**GOVERNMENT OF THE DISTRICT OF COLUMBIA
DEPARTMENT OF TRANSPORTATION**

MEMORANDUM

CASE NO. 18558

SUBJECT: **DDOT Review of BZA Case #18558, The Coliseum (Uline Arena) 1140, 3rd Street NE**

Figure 1: Proposed Site Layout and Access.

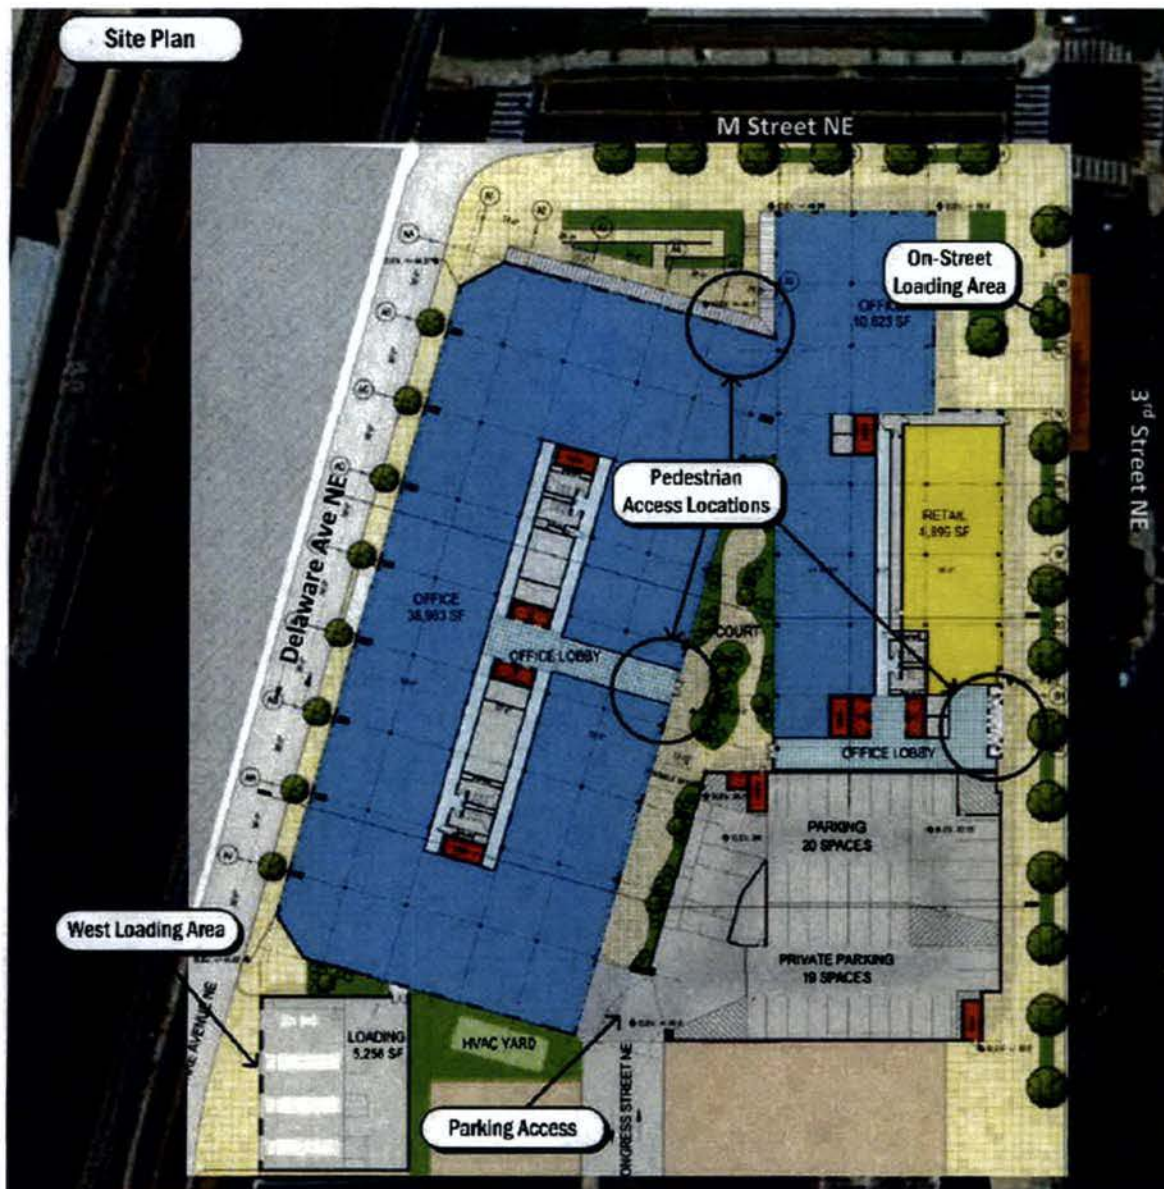
Pedestrian access for the site will occur along M Street, 3rd Street, and via an interior entranceway in the middle of the site. Truck access will be located via a loading area along Delaware Avenue and a proposed curbside loading zone on 3rd Street.

The parking access is proposed to be via a curb cut on Congress Street NE. Congress Street has a 24 foot cross section with regular loading and parking on either side. As currently designed and programmed, Congress Street will be too narrow to accommodate parking garage access as vehicles will not be able pass each other due to loading or parking activity along Congress Street. The Applicant has suggested instituting parking restrictions on one side of Congress Street in order to facilitate access to the parking structure: DDOT requests that, as a condition of approval for the parking variance, the Applicant work

DDOT's practice is to accommodate vehicle loading in a reasonable and safe manner while at the same time preserving safety across non-vehicle modes. For new developments, DDOT requires that loading takes place in private space and that no back-up maneuvers occur in the public realm. As shown in *Figure 1*, loading for the site is proposed to take place via an approximately 85 foot curb cut on Delaware Avenue. Due to the orientation of historic buildings on the site and other constraints, back-up maneuvers in the public realm and the non-standard curb cut are unavoidable.

with DDOT and the property owners along Congress Street to develop an acceptable cross section for Congress Street that will result in fewer potential delays for vehicles using the street. A DDOT public space permit will be contingent on successfully addressing access concerns.
